ADDENDUM No. 2
REQUEST FOR TENDER No. Doc5098158970
CONTRACT No. 25-PR-037

FOR: Bluffer's Park East Washroom Improvements and Exterior Works

- R1.** Replace Drawings E101, E201, E301, E401, E501 & E601 with the attached revised drawings issued with this Addendum.

GROUND FLOOR - LIGHTING - EAST BUILDING
SCALE: 1:50

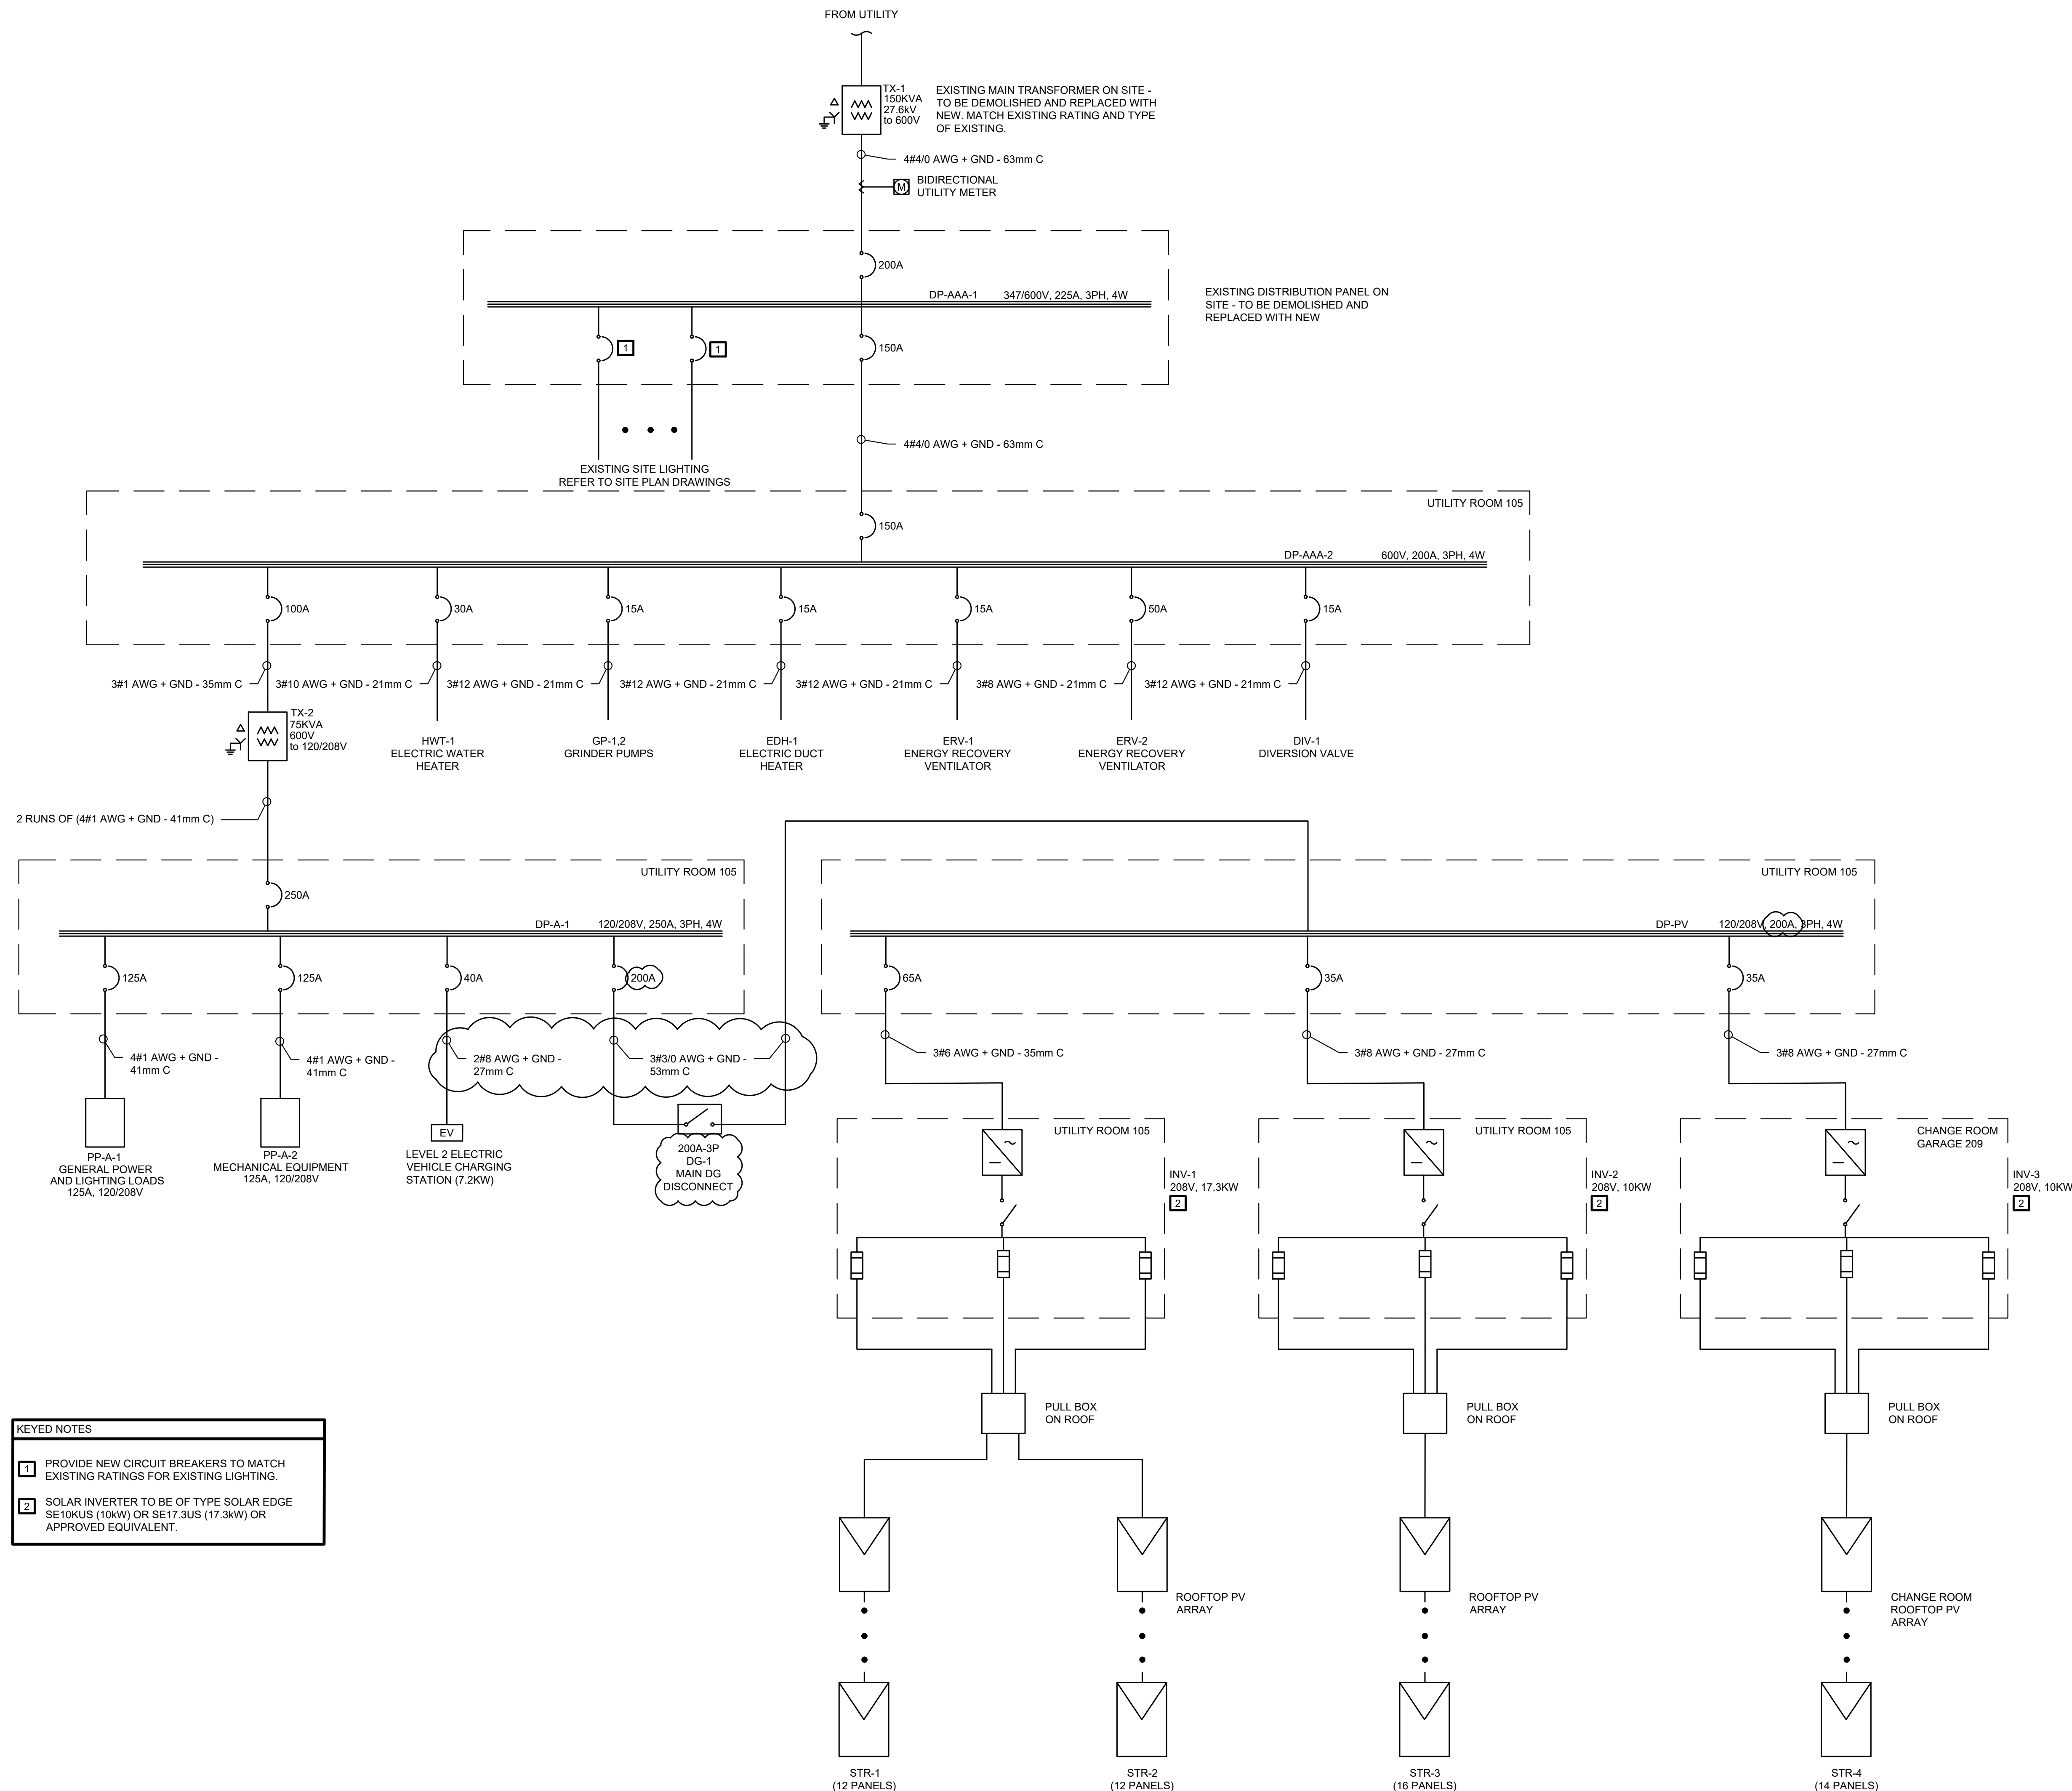
1.2 E201 – GROUND FLOOR – LIGHTING PLAN

- a. Added tags for remote heads RH.
- b. Added tags for battery units BU.
- c. Added tags and circuits for exit signs X1.

E501

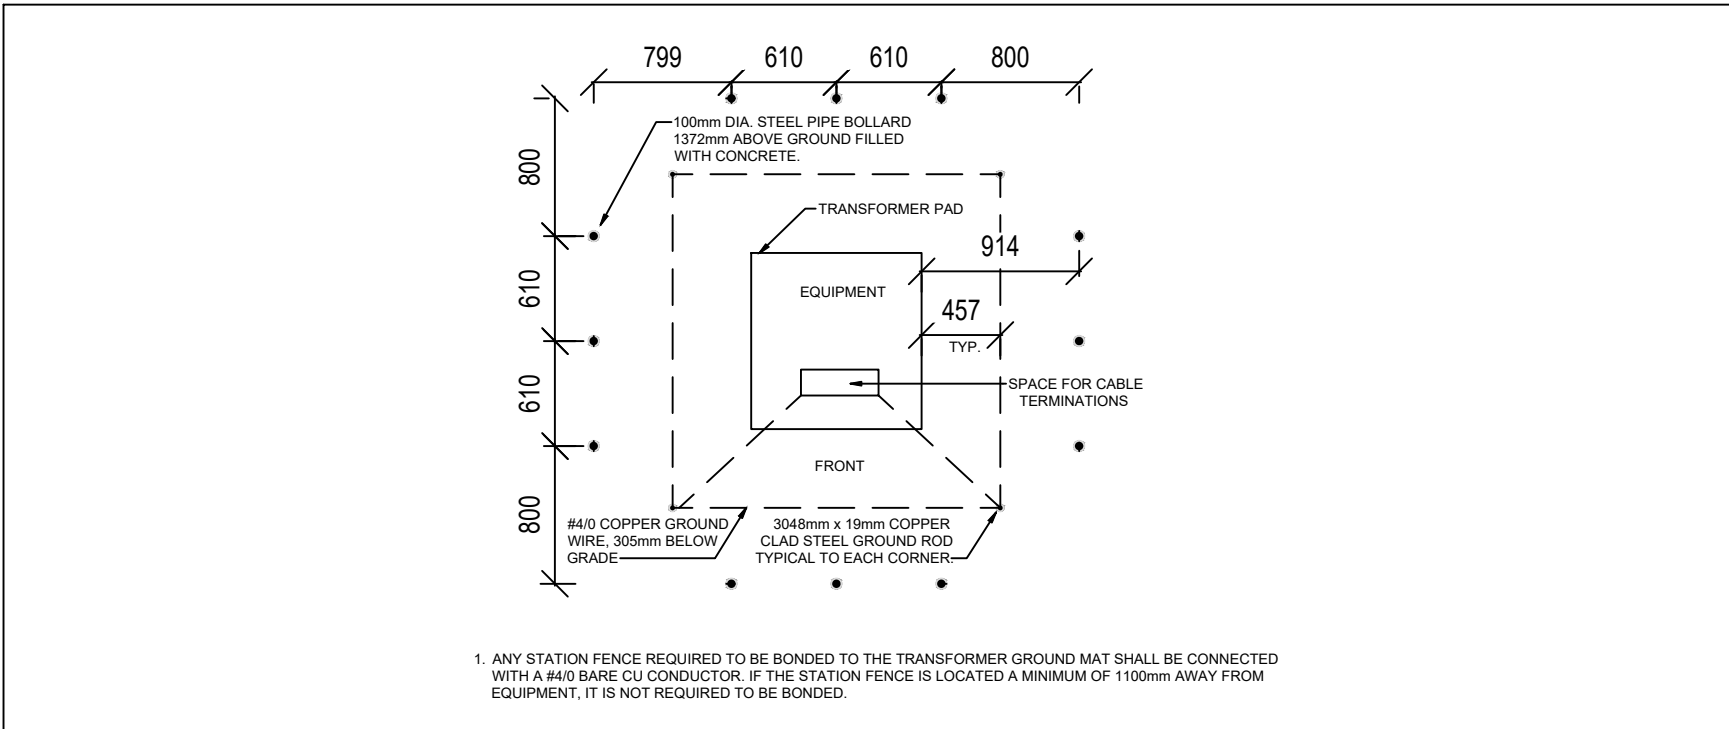
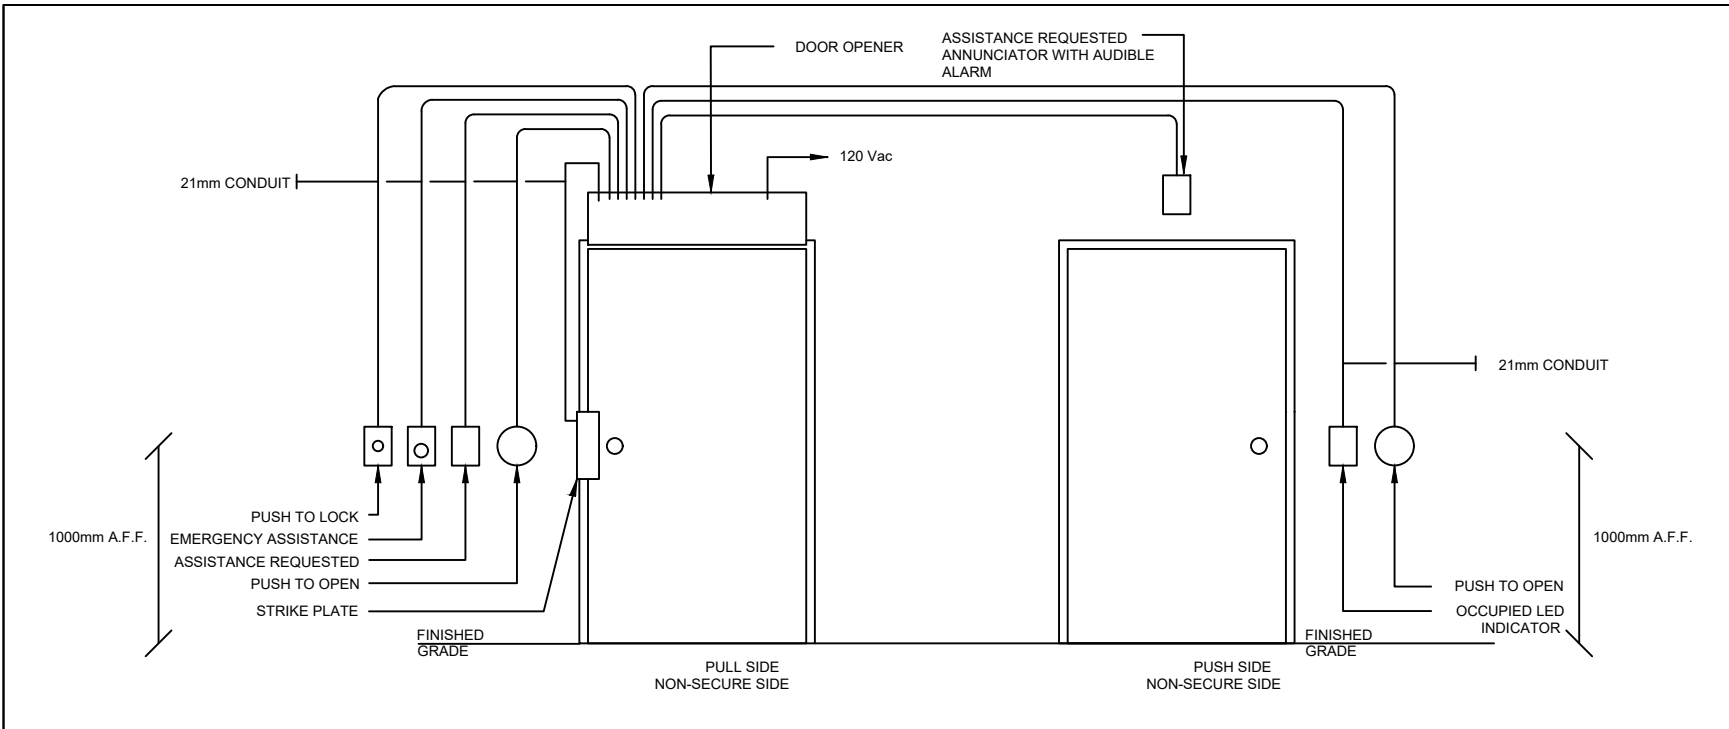
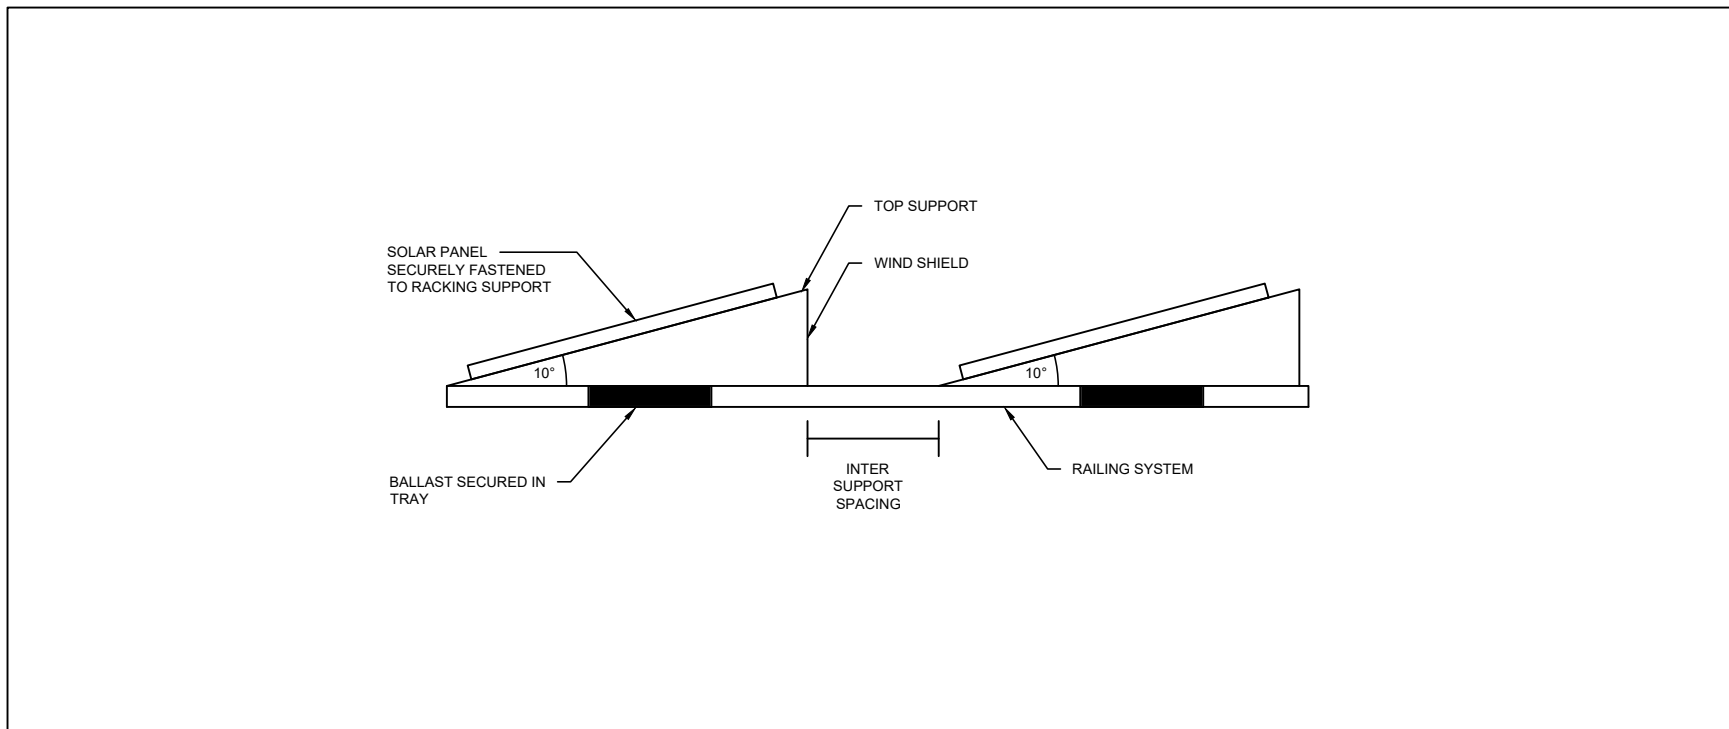
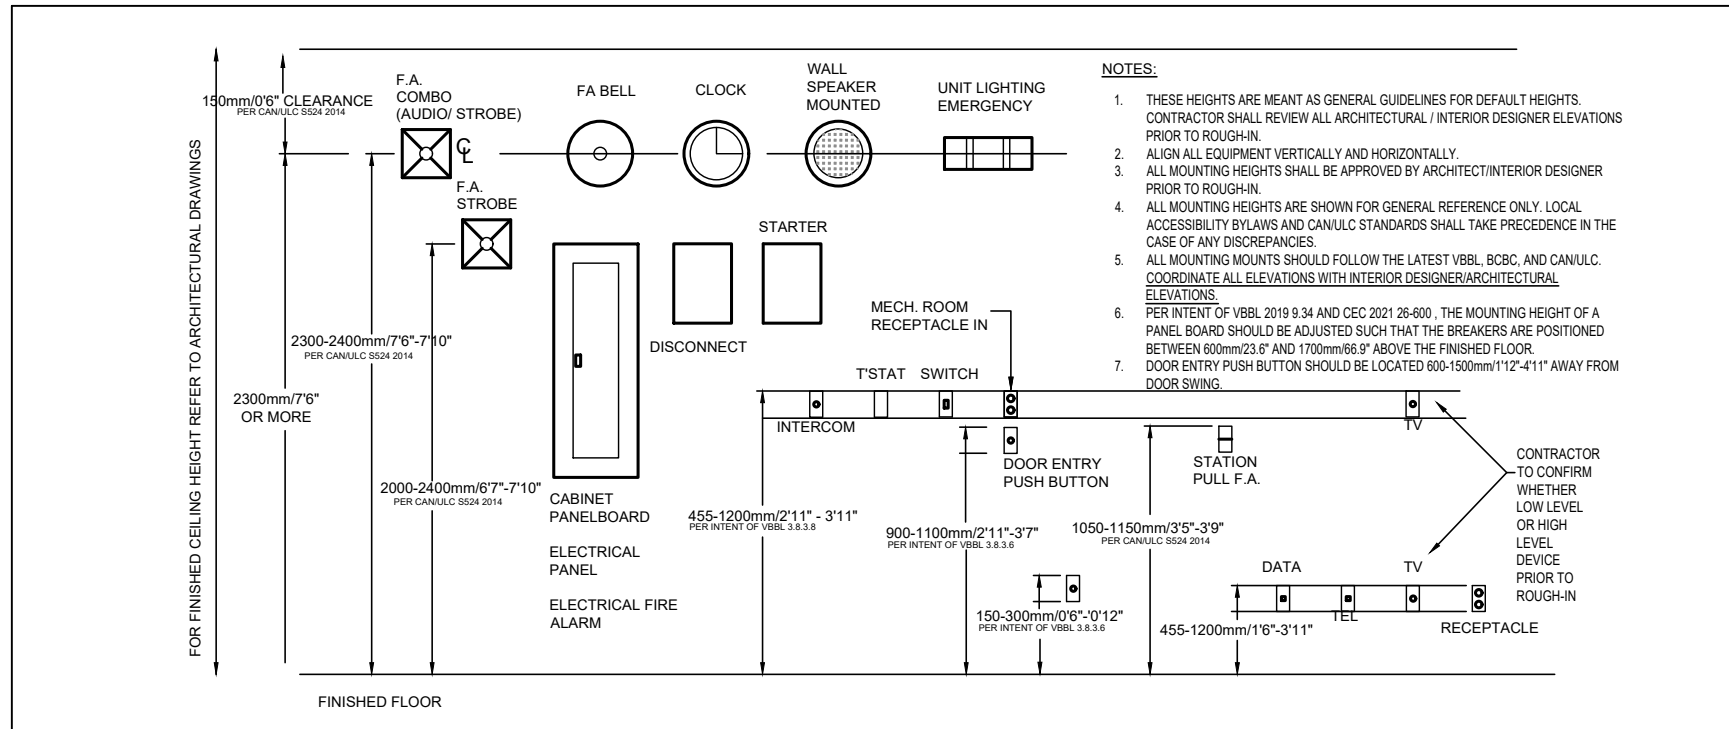
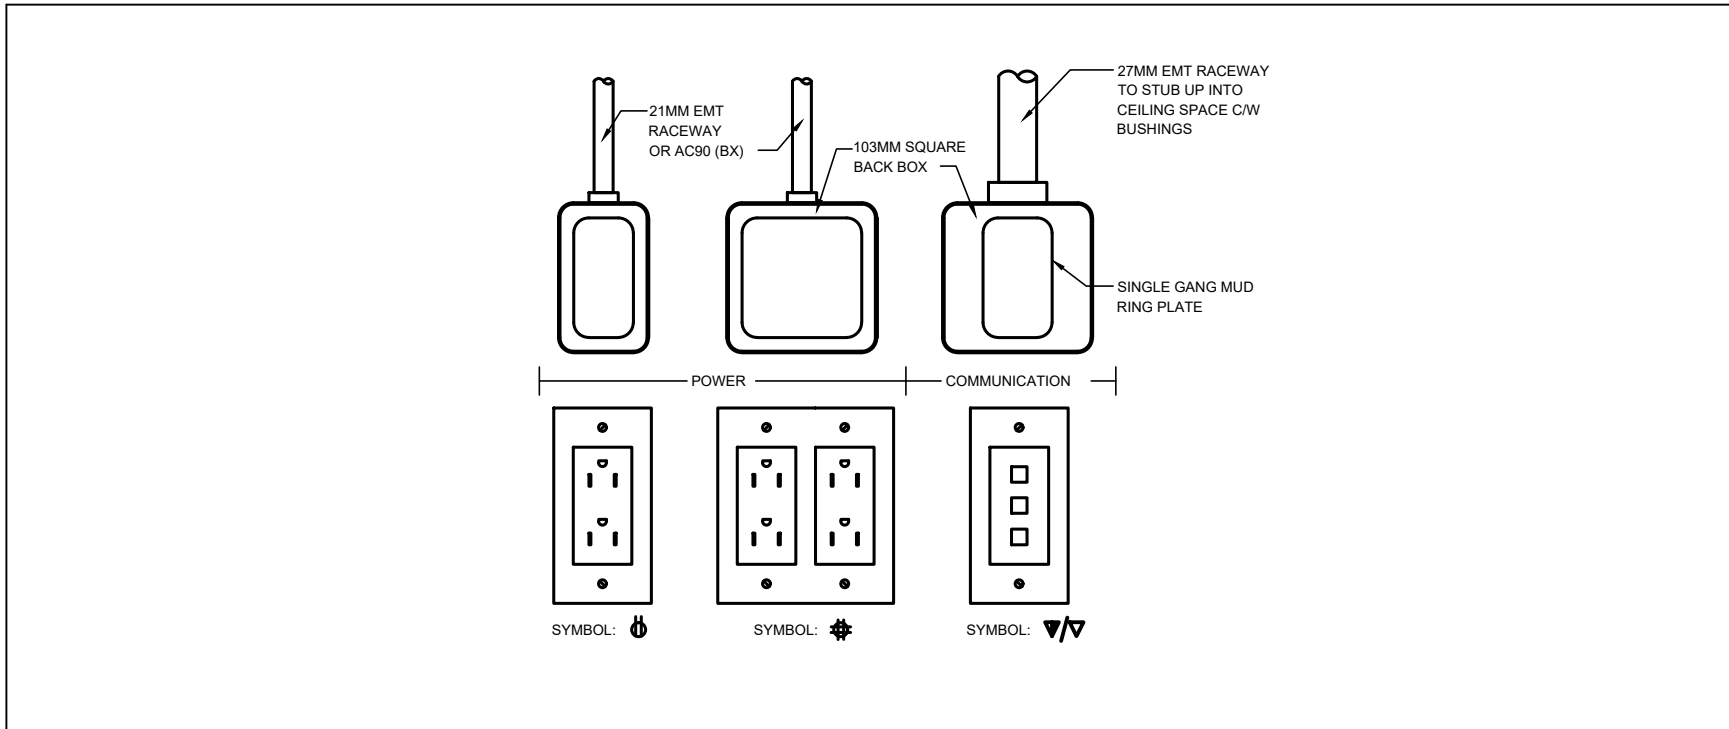
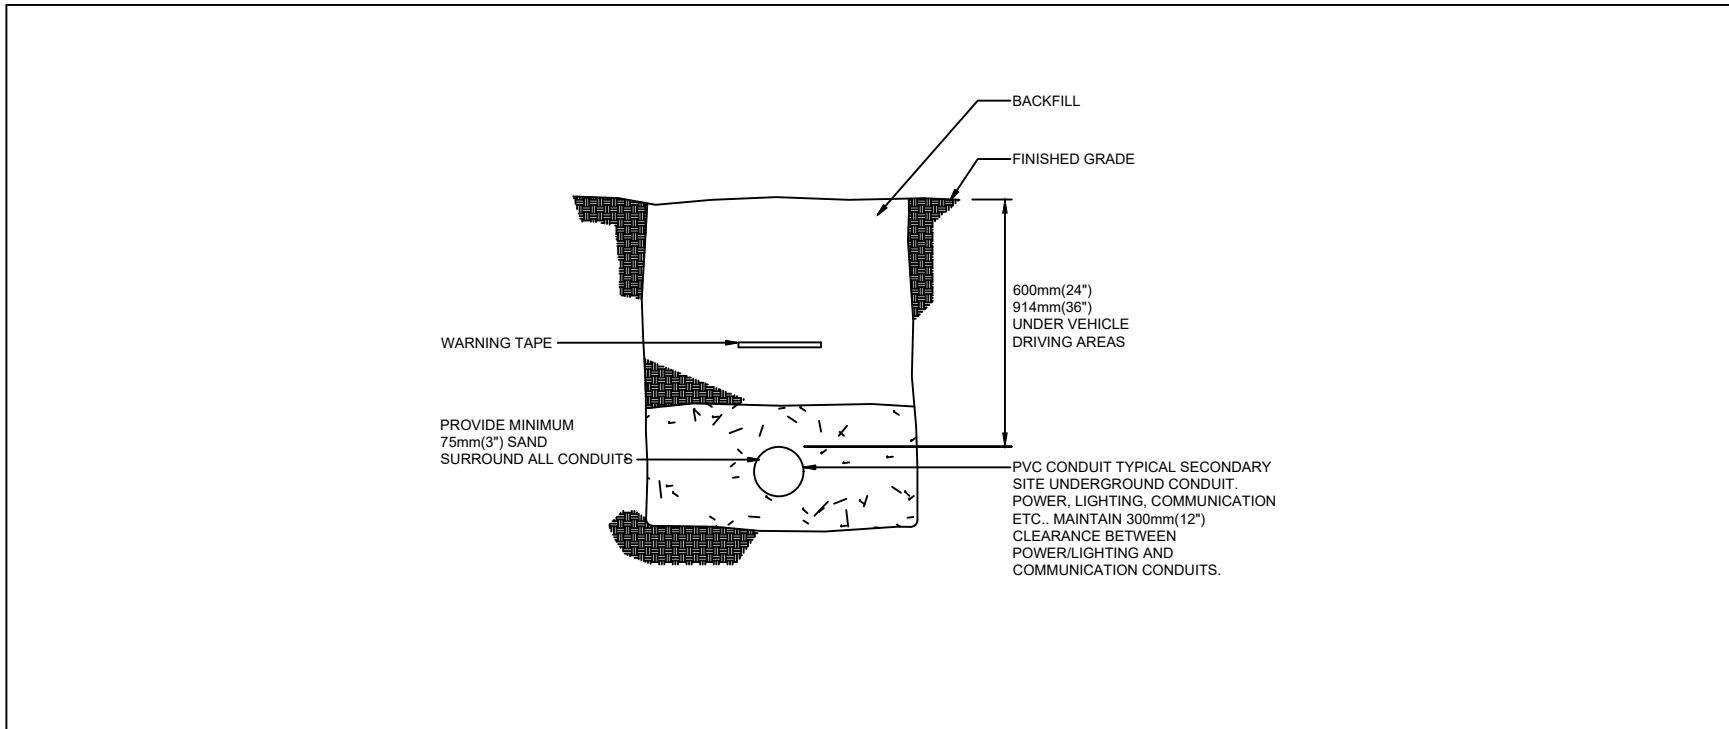
1.5 E501 – ELECTRICAL DETAILS

- a. Duplicate detail #8 removed.
